Purpose of Change

Re: Application for a Permissive Change Filing with FCC ID: EW780-6270-00

Explanation of the RFIC used for FCC Part 15 permissive change

Figure 2.2.1 Block Diagram of PNX801x

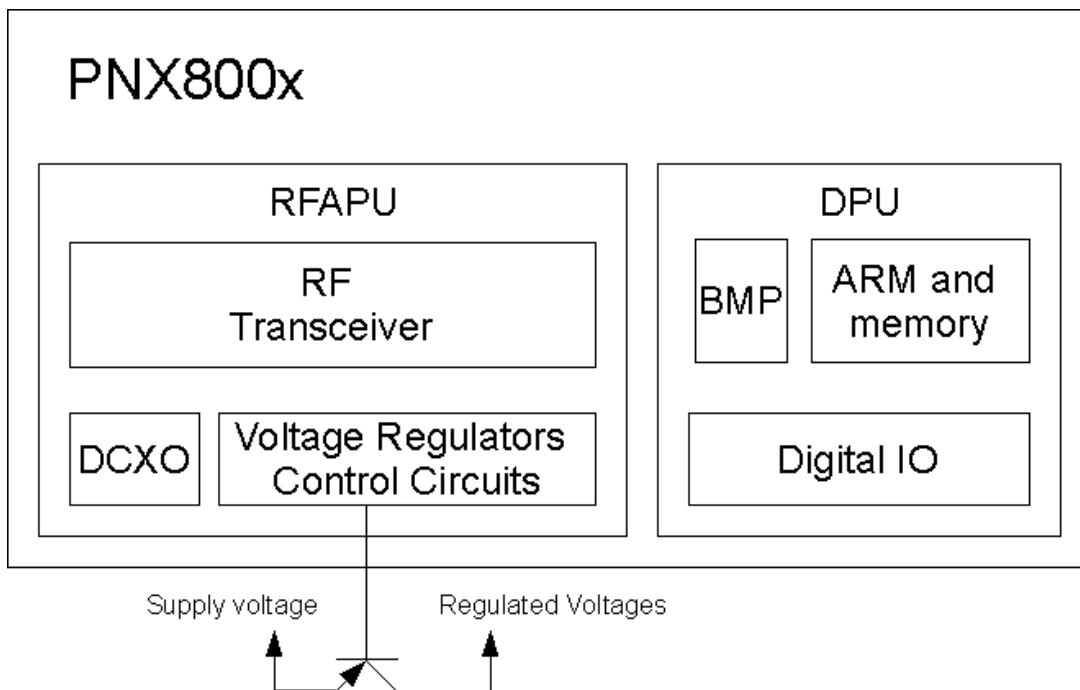
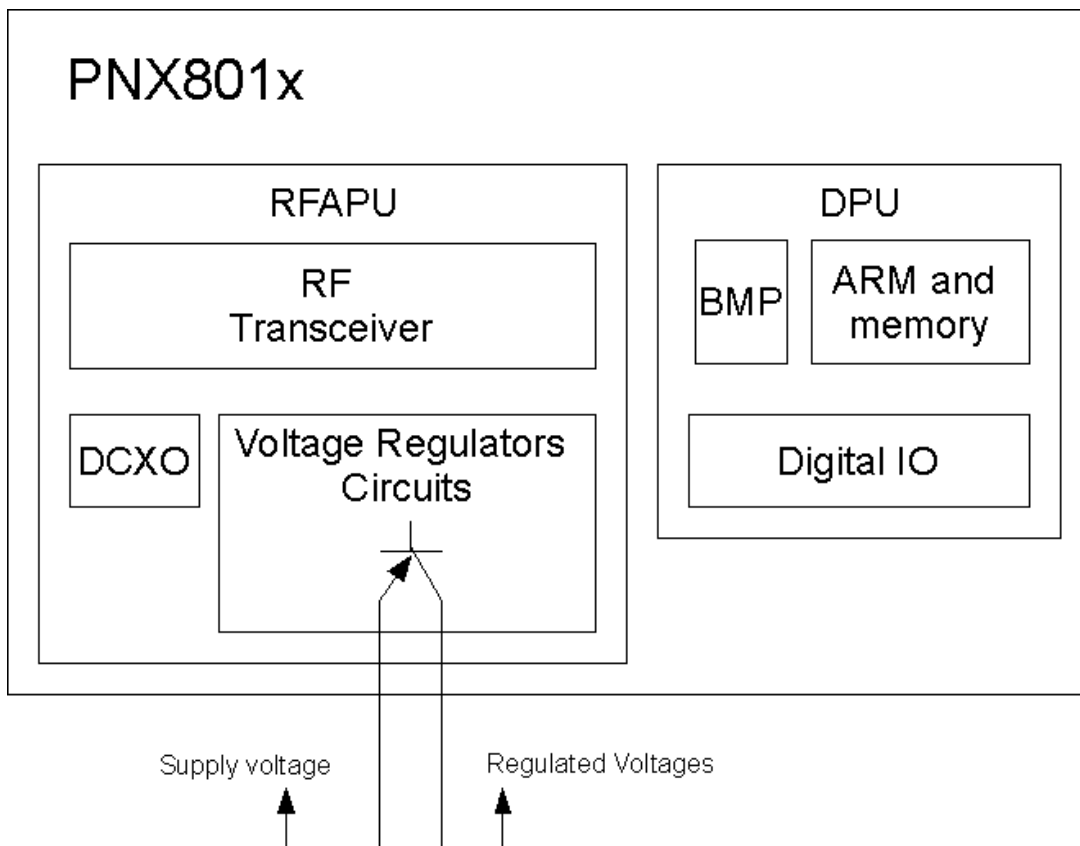
This document is aimed at explaining the differences between the RFIC PNX800x and its low cost successor PNX801x in order to apply a permissive change using PNX801x with the same FCC ID as PNX800x.

The PNX801x family is the low cost successor of the PNX800x family. It shares the same architecture and the same package (HVQFN88). The only difference between PNX800x and PNX801x is the built-in voltage regulator transistors. The whole RF architecture and other blocks are remained unchanged.
